To the Plans and Specifications for: **OAKLEY JR. / SR. HIGH SCHOOL  
CLASSROOM ADDITION & GYMNASIUM  
CASSIA SCHOOL DISTRICT #151  
3650 OVERLAND  
BURLEY, ID 83318**

**TO ALL CONTRACTORS SUBMITTING BIDS ON THE ABOVE SUBJECT:** This Addendum is hereby made a part of the Contract Documents pertaining to the above project and shall be binding upon each contractor submitting bids. Bid submitted shall be for the full and complete cost of incorporating these changes into the contract – no further claims shall be allowed for work associated with this addendum. It shall further be the responsibility of each Contractor to notify his subcontractors and suppliers concerning the contents of this addendum as they specifically apply to them. Acknowledge receipt of this Addendum in the space provided on the Bid Form. Failure to do so may subject Bidder to disqualification.

END OF ADDENDUM NO. 2

**ATT-2-3**

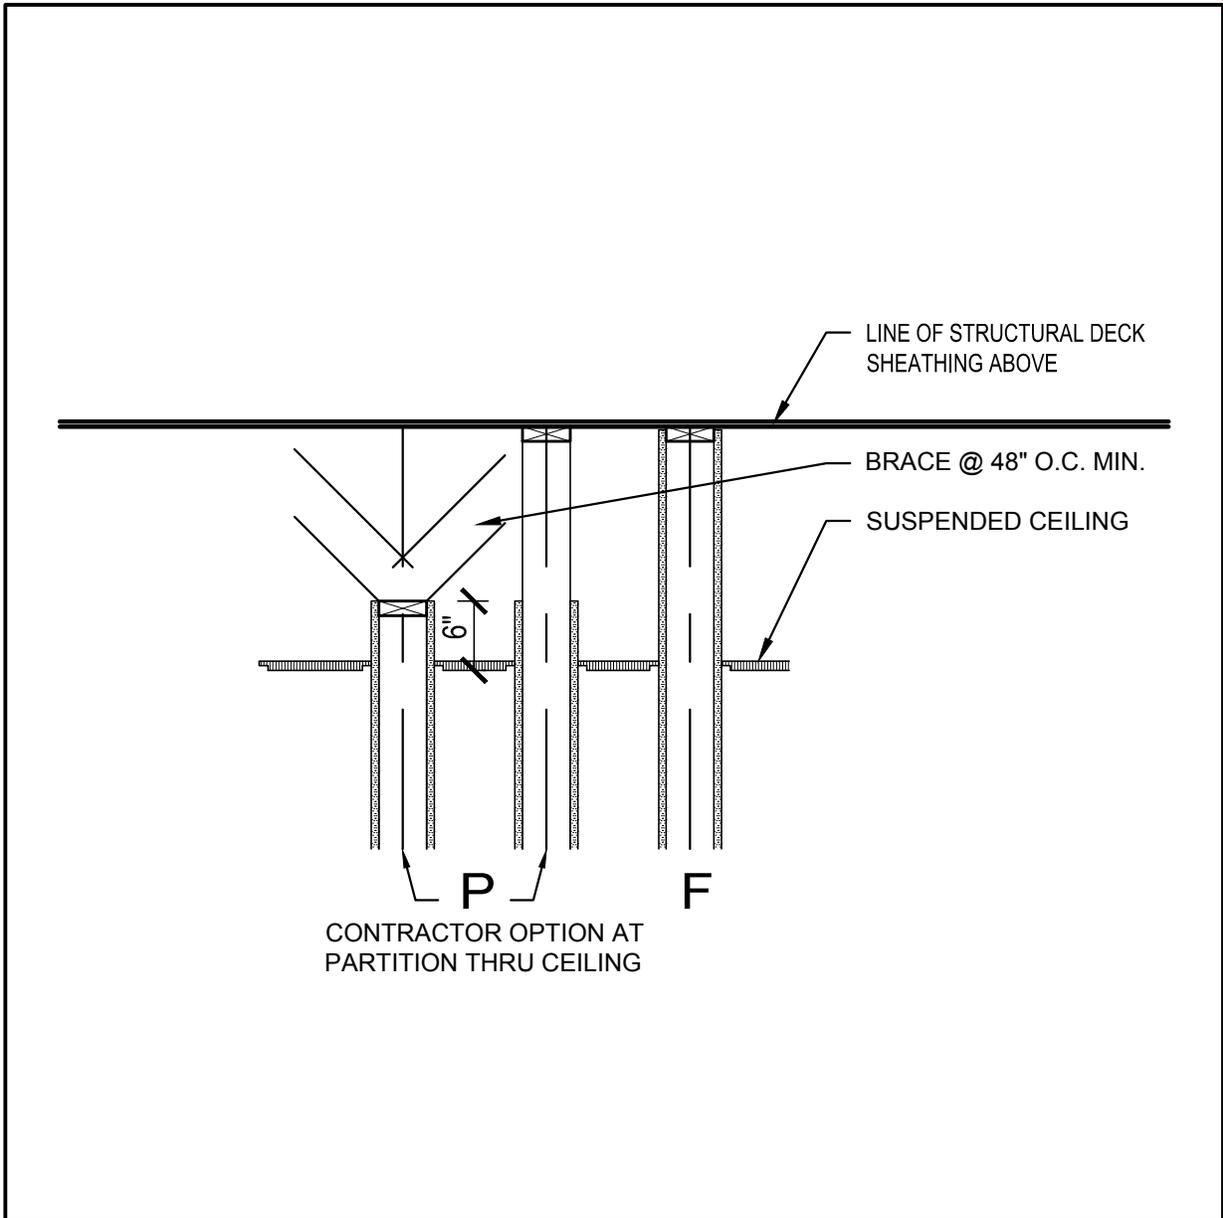
- 2-6 Sheet 3.31 Classroom Floor Plan
  - 2-6.1 Wall Assembly OW3.5-3 indicates 7/16" plywood. See Structural Sheet S2.01 for plywood shear wall locations.
  - 2-6.2 Add keyed note #5, see ATT-2-1.
  - 2-6.3 Adjust framing adjacent to drinking fountain to allow minimum 18" clear from center line of fountain to nearest wall surface.
- 2-7 Sheet 3.41 Classroom Floor Finish Plan
  - 2-7.1 Add Wall Type Legend, see ATT-2-3, 2-4, & 2-5.
- 2-8 Sheet 3.42 Gymnasium Floor Finish Plan
  - 2-8.1 Add stained concrete boarder and symbol as shown on ATT-2-9. Stone flooring material and labor to be donated. Coordinate recessed flooring and setting bed prior to installation.
  - 2-8.2 Omit reference to stained concrete flooring at Wrestling Room #126. Omit reference to special beveled saw cut joints identified in C11/A3.42. Standard saw cut @ 10'-0" o.c.

**ATT-2-8**

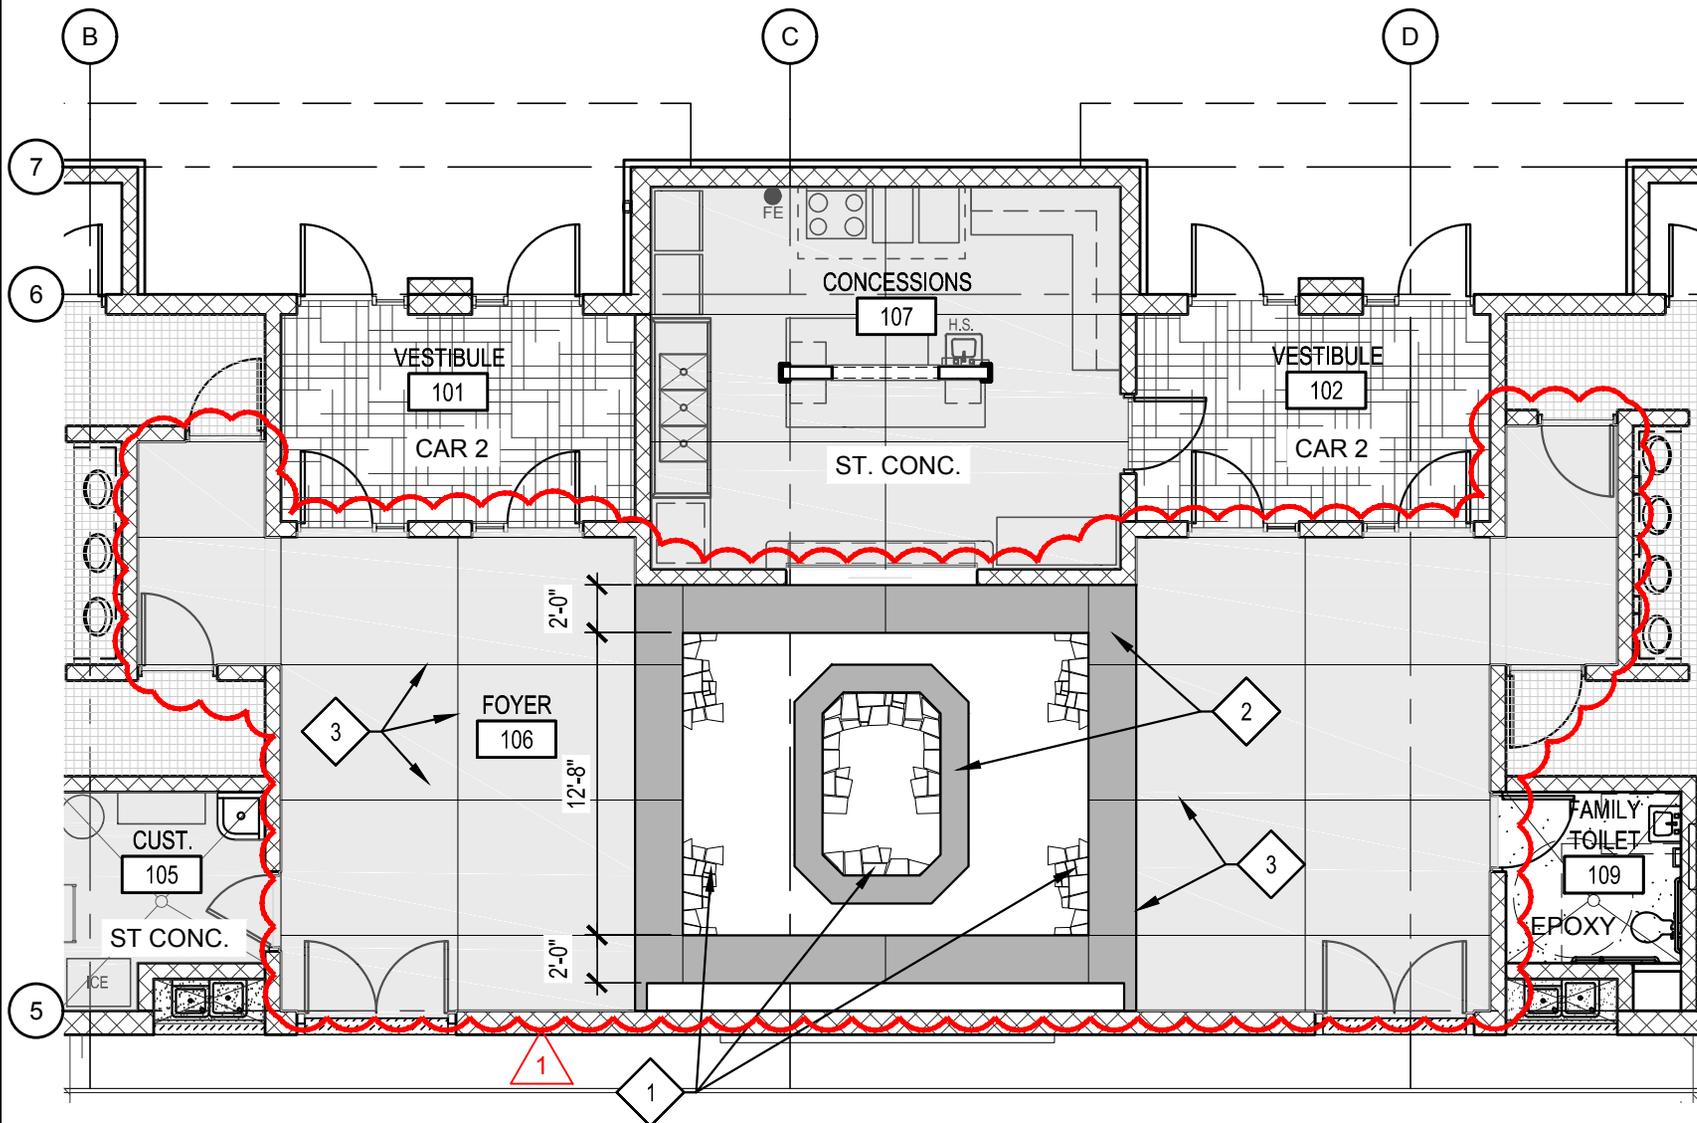
- 2-9 Sheet 3.71 Classroom Floor Finish Plan
  - 2-9.1 Revise Equipment Schedule, see ATT-2-8. See 114000 for detailed equipment list.
- 2-10 Sheet A6.00 Doors, Windows and Details
